CPSES-200102929
Log # TXX-01187
File # 00236, 10010 (clo)

SUBJECT: COMANCHE PEAK STEAM ELECTRIC STATION (CPSES)
DOCKET NOS. 50-445 AND 50-446
LICENSE AMENDMENT REQUEST (LAR) 01-14
REVISION TO TECHNICAL SPECIFICATION (TS) 5.5.16
CONTAINMENT LEAKAGE RATE TESTING PROGRAM

5.5.16. Containment Leakage Rate Testing Program

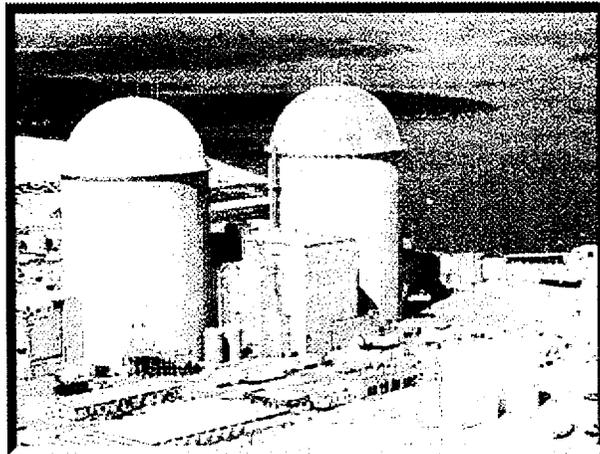
- a. A program shall be established to implement the leakage rate testing of the containment as required by 10 CFR 50.54(o) and 10 CFR 50, Appendix J, Option B, as modified by approved exemptions. This program shall be in accordance with the guidelines contained in Regulatory Guide 1.163, "Performance-Based Containment Leak-Test Program, dated September, 1995" as modified by the following exception:

1. NEI 94-01 - 1995, Section 9.2.3: The first Type A Test performed after the December 7, 1993 Type A Test (Unit 1) and the December 1, 1997 Type A Test (Unit 2) shall be performed no later than December 15, 2008 (Unit 1) and December 9, 2012 (Unit 2)."
